Re: Plains Pipeline, L.P. Hobbs Junction Mainline (Plains SRS#2003-00017)
NMOCD Reference # AP-054
UL-M (SW¼ of the SW¼) of Section 26, T18S, R37E
Latitude: 32° 42' 40.85"N and Longitude: 103° 13' 42.01"W
Landowner: State of New Mexico and Ms. Faye Klein
Lea County, New Mexico

Plains Pipeline, L.P. (Plains), submits this response to the email sent by the New Mexico Oil Conservation Division (OCD) dated February 20, 2008. This Addendum corresponds to the Stage 1 and Stage 2 Abatement Plan dated August 2004. The recommendations are reiterated below followed by the Plains response.

Hobbs Junction Mainline #2003-00017

Proposed Monitor Well Location

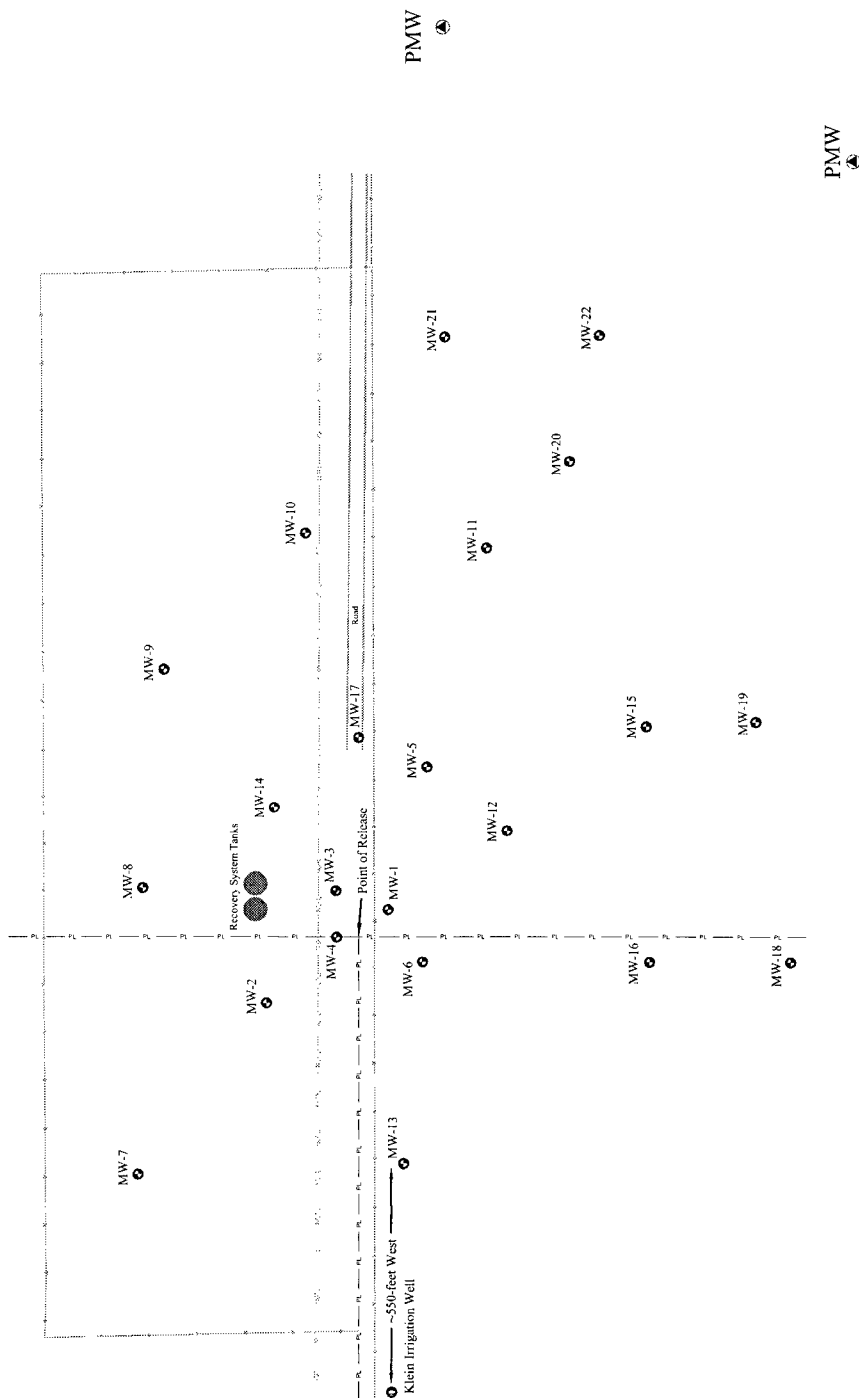
3. "The groundwater monitoring program must specify that at least two additional groundwater monitoring wells will be installed downgradient of the existing monitoring wells (including the proposed well locations)."

Response: As requested, two monitor wells will be installed downgradient from the existing monitor wells in March 2008. One monitor well will be located approximately 200 feet east of monitor well MW-21. The other requested monitor well will be installed approximately 200 feet southeast of monitor well MW-22.
